COUNCIL SUPPLEMENTARY REPORT

SYDNEY SOUTH PLANNING PANEL

PANEL REFERENCE & DA NUMBER	PPSSSH-154 – DA 2023/0487
PROPOSAL	Demolition works, marina expansion, construction of a new carpark, alterations and additions to the existing club
ADDRESS	2 Wellington Street, Sans Souci (Gorges River LGA) – Lot 1 DP 956068, Lots 1, 2 & 3 DP 1012626, Lot 5A Sec 9 DP 1816, Lot 1 DP 957802, Lot 1 DP 441596, Lot 1 DP 106035, Lot 1 DP 78902
APPLICANT	The St. George Motor Boat Club Ltd
OWNER	The St. George Motor Boat Club Ltd
DA LODGEMENT DATE	25 October 2023
APPLICATION TYPE	Development Application - Designated (s4.10 of EP&A Act & Schedule 3 of Regulations) & Integrated Development (s4.46 of the EP&A Act)
REGIONALLY SIGNIFICANT CRITERIA	Section 2.19(1) and Clause 7(1)(b) of Schedule 6 of <i>State Environmental Planning Policy (Planning Systems) 2021</i> declares it regionally significant development as it proposes Particular Designated Development being marinas or related facilities that meet the requirements for designated development under Schedule 3, section 32 of the <i>Environmental Planning and Assessment Regulation 2021</i>

Figure 40: Proposed entry structure (Source: Innovate, Revision F)

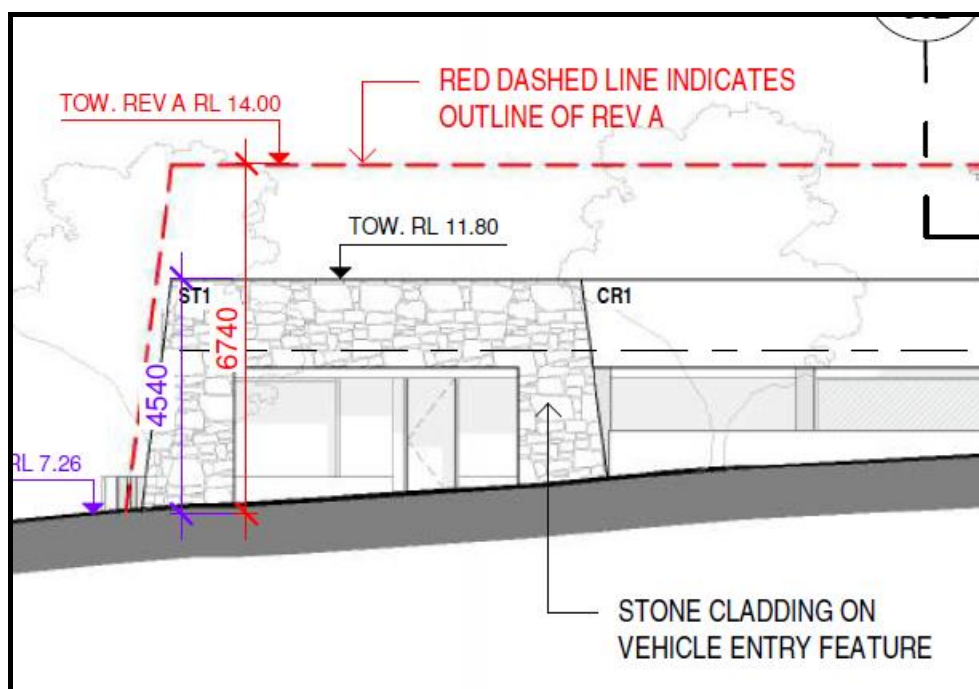
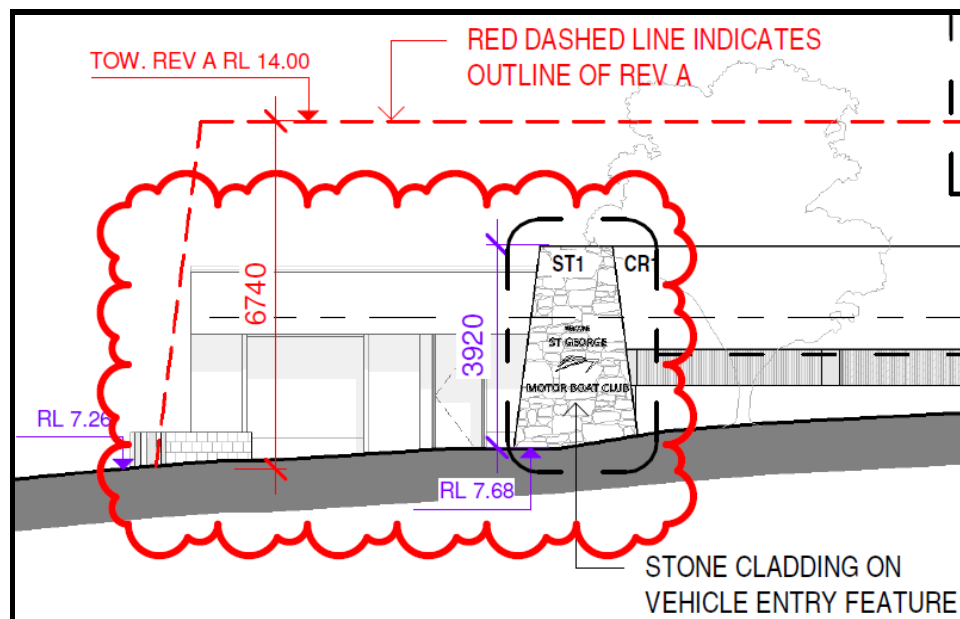
A sandstone entry structure of approximately 8.2 metres in length and 4.54 metres high in which vehicles would pass under to enter the site from Plimsoll Street (**Figure 39**) was outlined in the previous (Revision C plans) proposal.

The amended proposal involves the removal of a 6.25 metre length of the southern portion of the first floor of the car park, which in turn reduces the size of this proposed entry structure (**Figure 40**).

While this entry feature has been reduced in size, it still comprises an additional building element to, and forward of, the wall of the first floor of the car park, which is already a significant structure and is forward of the prevailing front building setback for the area (Figure 41). This additional building structure further encroaches into this front setback area (Figure 42) and reduces the opportunities for landscaping along the Plimsoll Street boundary (Figure 43). This position forward of the remaining sections of the proposed new car park structure and the lack of landscaping, exacerbates the bulk and scale of the proposed structure to the street.

Therefore, this vehicle entry feature is not supported and is recommended to be removed from the proposal and replaced with sandstone flagging on the southern edge of the car park structure. A relevant design change consent condition is recommended in **Attachment A**.

- (a) The vehicle entry structure at Plimsoll Street must be removed and replaced with stone cladding on the southern edge of the car park structure only. Landscaping shall be incorporated along the frontage of the site at this Plimsoll Street vehicle entry point and is to be outlined on the Final Landscape Plan;

Figure 42: Proposed Vehicle Entry Structure - Plimsoll Street (Source: Innovate, Revision F)

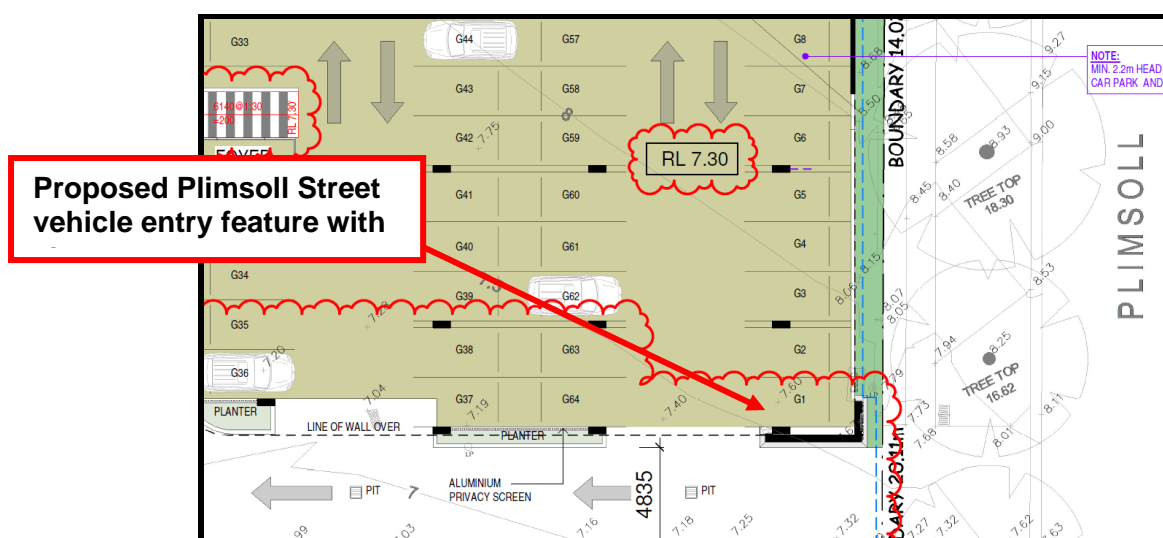
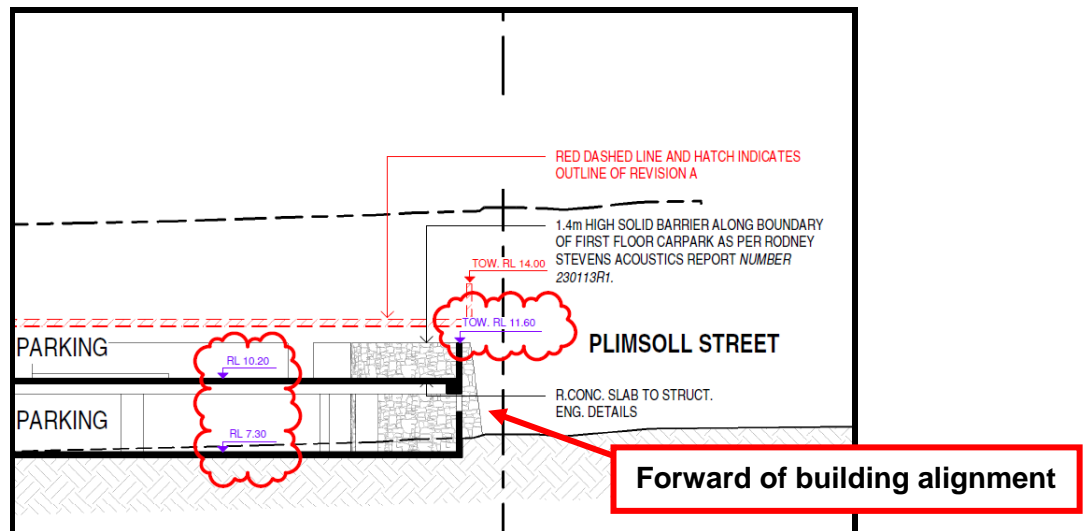
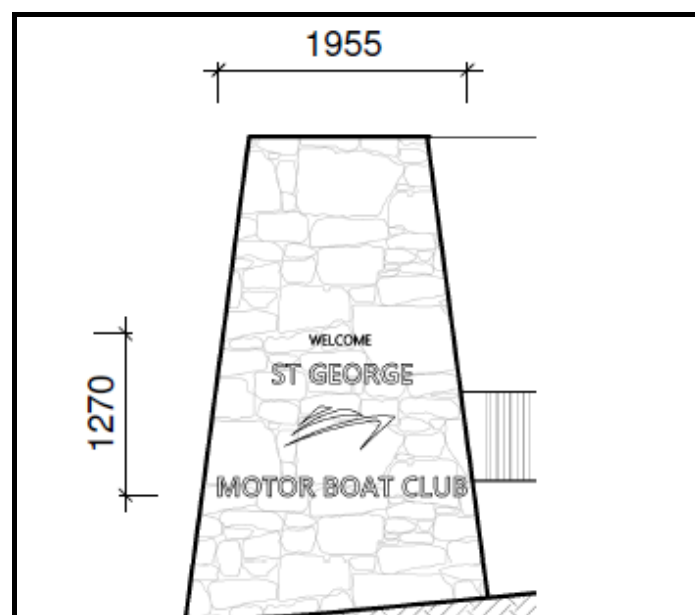
Further, this vehicle entry structure, similar to the original proposal, still consists of stone cladding at a height of 3.92 metres, a base of 2.5 metres and narrowing to 1.955 metres at the top of the structure. Business identification signage of a height of 1270mm is proposed to be constructed on the vehicle entry structure (Figure 44). Such cladding and signage adds further bulk to the structure.

Council's Senior Specialist Planner (Urban Design) considers that this vehicle entry structure should be setback around 2.5 metres from the street boundary to minimise the dominance on the streetscape, however, this setback cannot be accommodated as the car park structure is only 1.64 metres from the Plimsoll Street boundary. Relocating the feature wall/vehicle entry structure to another position on the site would likely result in the loss of car parking or manoeuvring area or reduce the proposed landscaping through the car park area (discussed below).
